2021-SMT-0150
10 CFR 50.30

SHINE Technologies, LLC Operating License Application Supplement No. 11
Submittal of a Revision to the SHINE Quality Assurance Program Description

**2000-09-01, REVISION 18
QUALITY ASSURANCE PROGRAM DESCRIPTION**

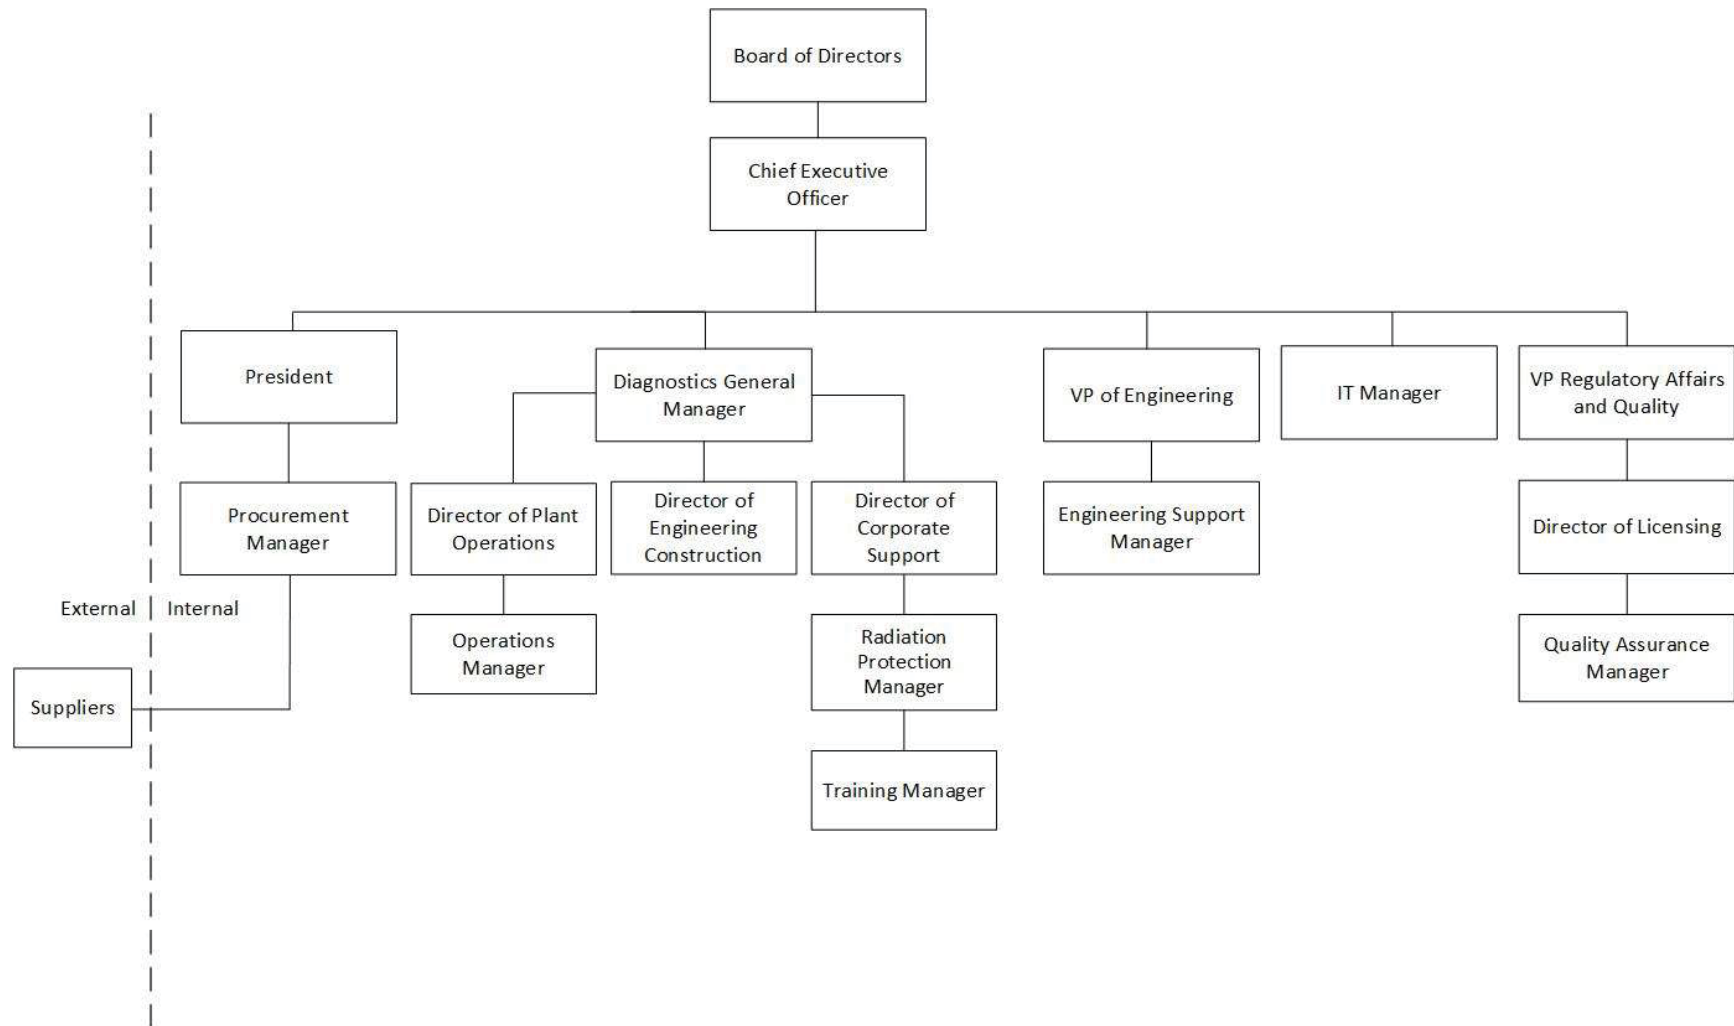
18	10/15/2021	Revised the organizational description in Section 2.1, "Organization," and Enclosure 1, "SHINE Functional Organizational Chart," to remove the roles of Chief Operating Officer (COO) and Plant Manager (PM) and add the roles of Diagnostics General Manager (DGM), Director of Plant Operations (DPO), and Director of Corporate Support (DCS). Revised Enclosure 3, "Procedures that Implement the QAPD," to update the procedure numbers and titles of the SHINE Implementing Procedures.	Change represents administrative improvements and organizational revisions which maintain that persons and organizations performing quality assurance functions continue to have the requisite authority and organizational freedom. Therefore, the revision does not represent a reduction in effectiveness against the QAPD previously approved by the NRC staff.
